12/06/03
rev. 27/08/03

To all TM Racing Dealers

IGNITION TIMING UPDATE KITS

Part code F 15431 (250 cc) / F 15432 (400 cc) / F 15440 (450 cc) / F 15441 (530 - 600 cc)

Picture 1

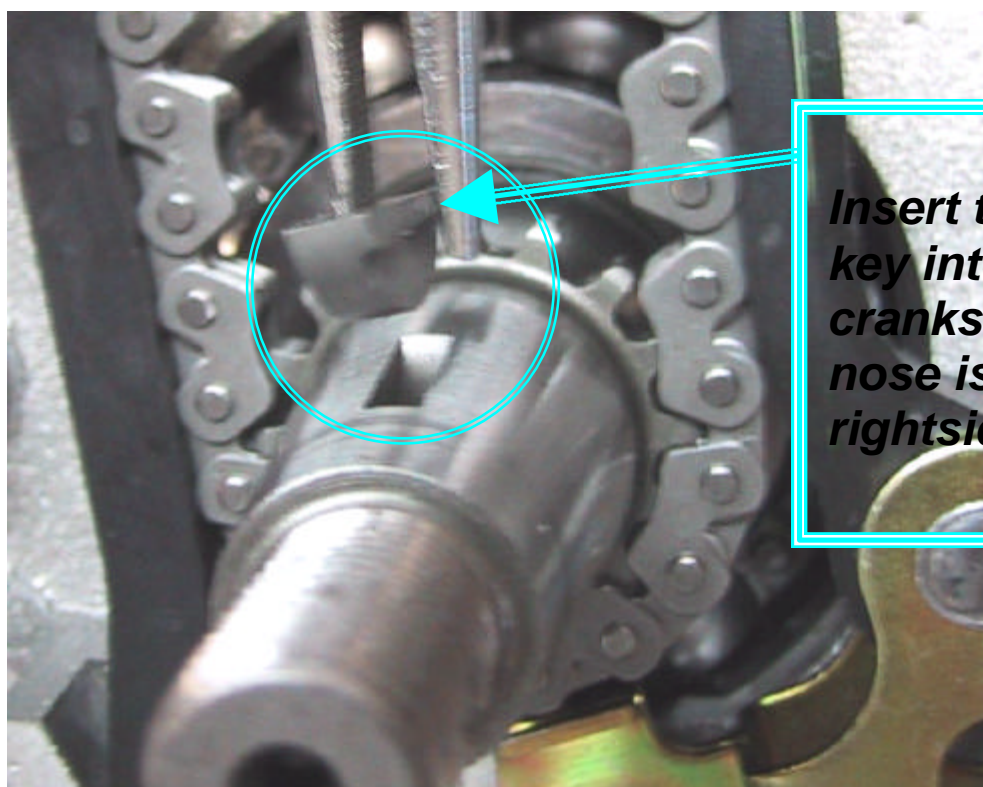
Assemble the F 49973 woodruff key on the shaft, being sure to dispose it like in the picture. With piston at TDC, the "L" side of the key should face right hand. Please refer to picture n. 1

Insert the woodruff key into the crankshaft so as the nose is pointing rightside

Picture 2

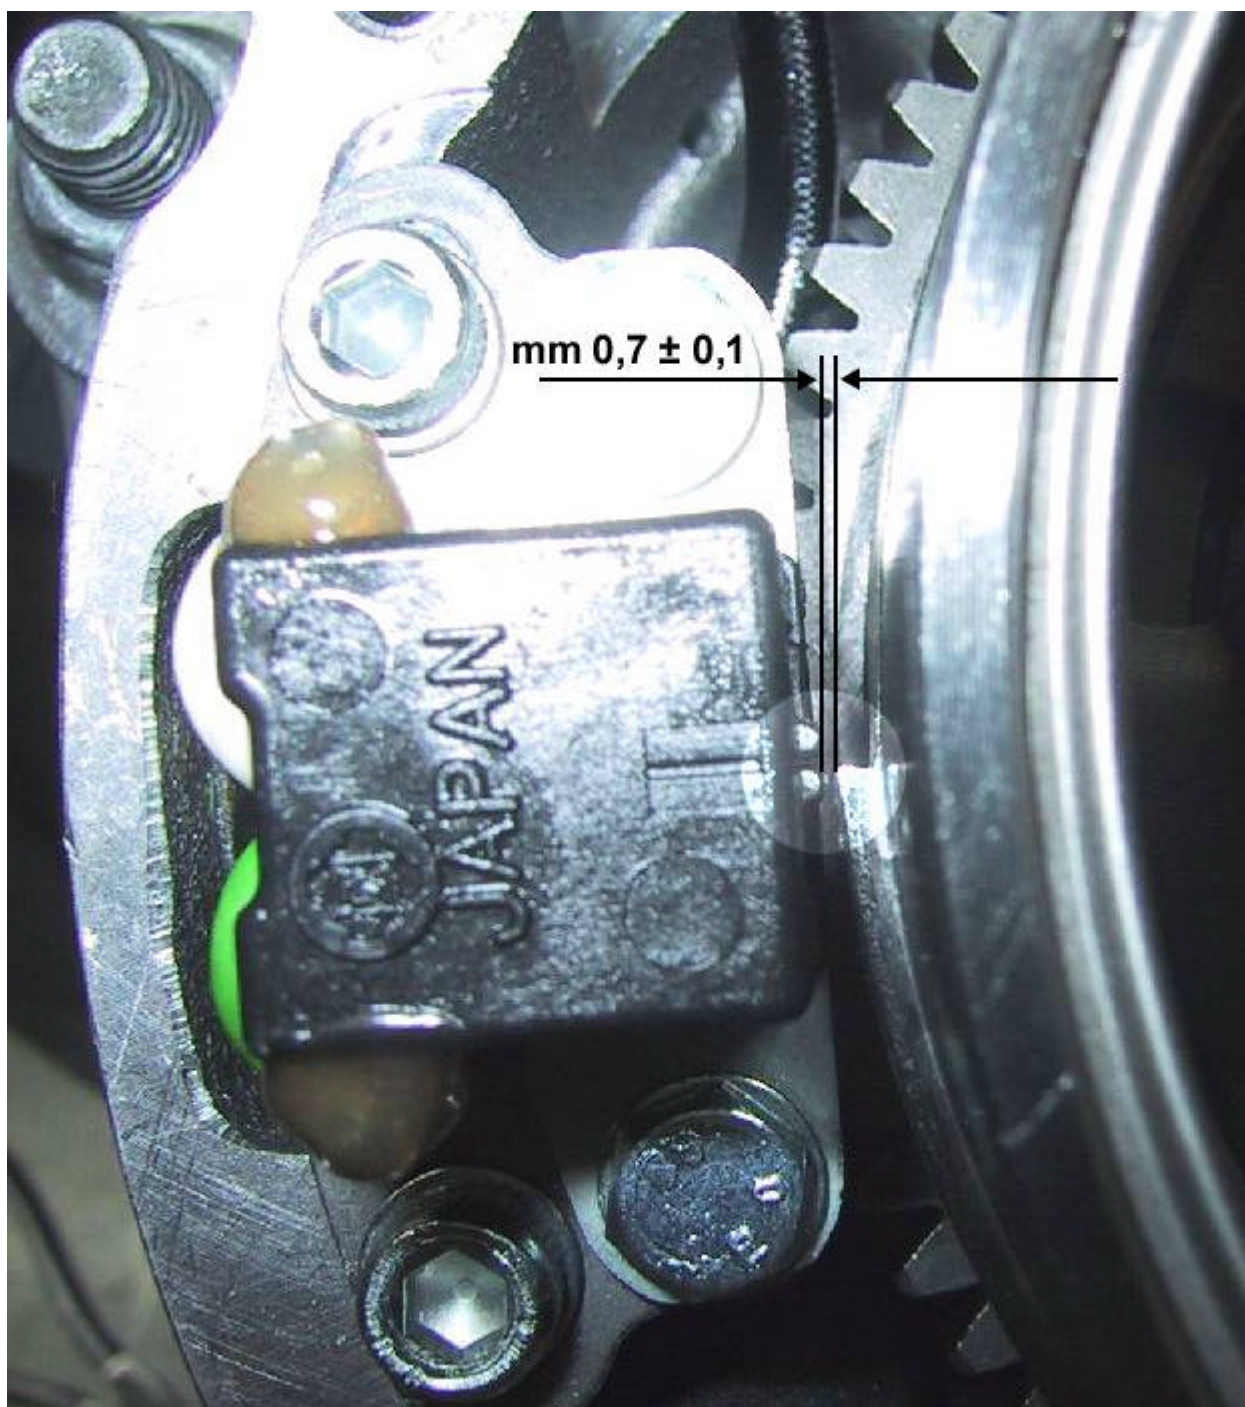
Check with the piston at 0 mm. BTDC (exactly at TDC) that the end of flywheel sector is facing the center of pulser coil (pickup) and that the distance between sector and pulser is correct. Please refer to picture n. 2.

Position between flywheel and pick-up when piston is 0° before T.D.C. If necessary, move the pick-up to adjust. Check if the distance between pick-up and flywheel is correct (Picture 2).
